PLANNING REPORT

Planning and Zoning Commission

Emerald Parkway Mixed-Use 26-046CP

Address	PID 273-010645, 273-010646, and 273-010647
Proposal	New mixed use development. The 16-acre site is located at the northeast corner of the intersection of Emerald Parkway and Woerner Temple Road.
Request	Review and non-binding feedback on a Concept Plan for future development.
Zoning	PCD, Planned Commerce District - Thomas Kohler
Planning Recommendation	<u>Consideration of the discussion questions</u>
Next Steps	Upon receiving feedback from the Planning and Zoning Commission (PZC), the applicant may incorporate the feedback and submit for a Preliminary Development Plan (PDP) and Rezoning (Z).
Applicant	Anna Brown, VanTrust
Case Manager	Zach Hounshell, Planner II (614) 410-4652 zhounshell@dublin.oh.us

Site Features

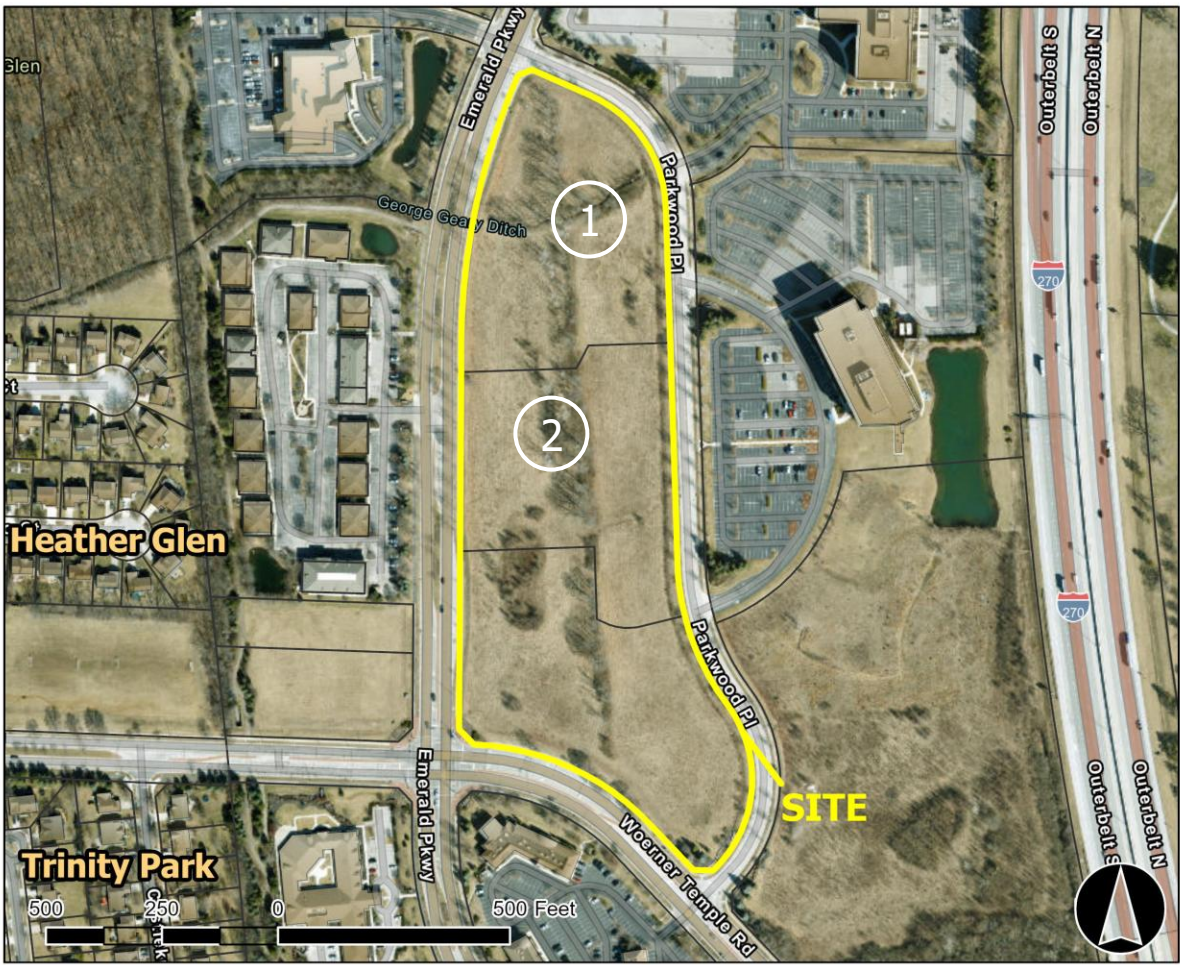
- 1 Glen Geary Ditch
- 2 Existing mature tree stand
